To: INCITS Technical Committee T10  
From: Kevin Butt  
Date: September 12, 2007 1:45 pm  
Document: T10/07-374r3 — SSC-3: End-to-end Logical Block Protection

**FIGURE 1. Protection information shown in relation to logical objects and format specific symbols**

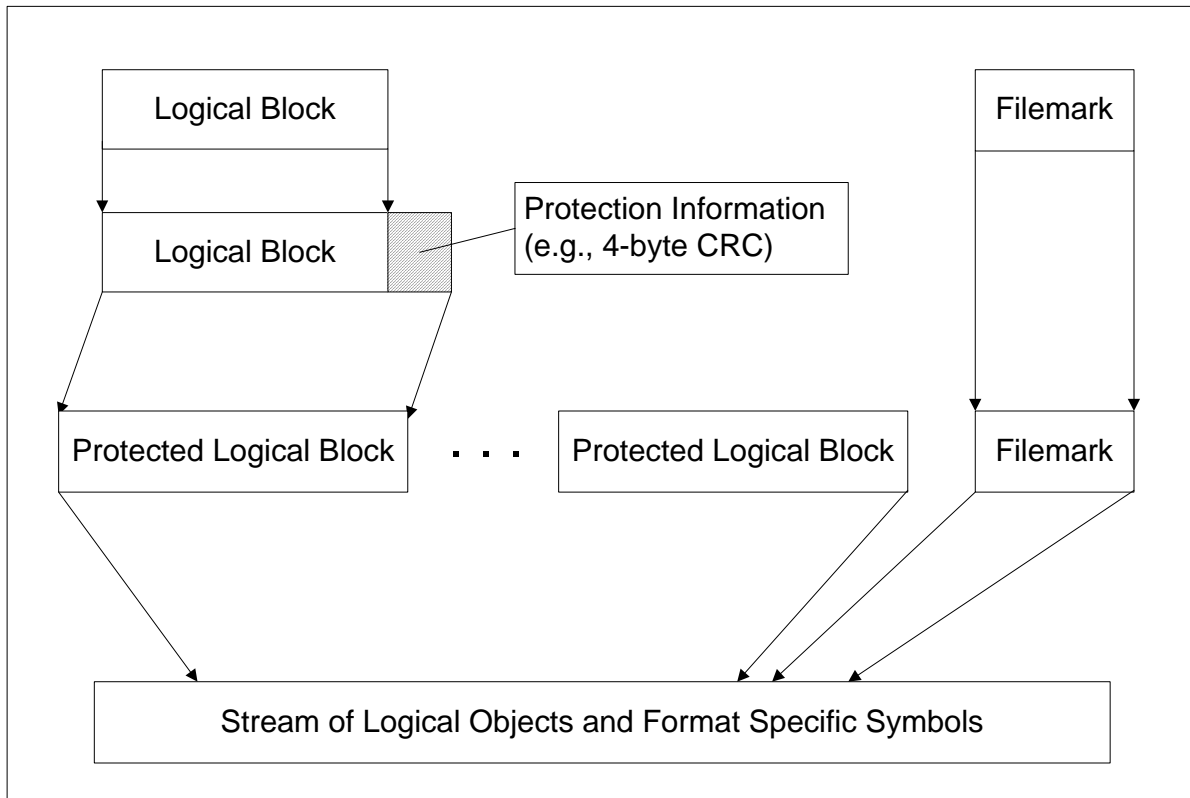
A recorded volume contains logical objects (see 4.2.7.1) and format specific symbols. Logical objects are application client accessible. Format specific symbols are used by the device server to provide methods for recording logical objects on the medium in a manner that allows them to be successfully read at a later date. Often format specific symbols contain information used to protect logical objects. If a device server supports a non-zero value in the LOGICAL BLOCK PROTECTION METHOD field of the Control Data Protection mode page it should include the protection information field as one of its format specific symbols. If the protection information field is not included as one of the device server's format specific symbols then the protection information field shall be transformed by the device server into a format specific symbol that provides the same level of protection as the protection information field. The format specific symbol that is the protection information field or the transformed protection information field shall be written to the medium with each logical block. The protection information field is accessible by the application client when the LOGICAL BLOCK PROTECTION METHOD field of the Control Data Protection mode page for the I\_T nexus through which that application client communicates is set to a non-zero value. A representation of logical objects and format specific symbols is shown in Figure 1.
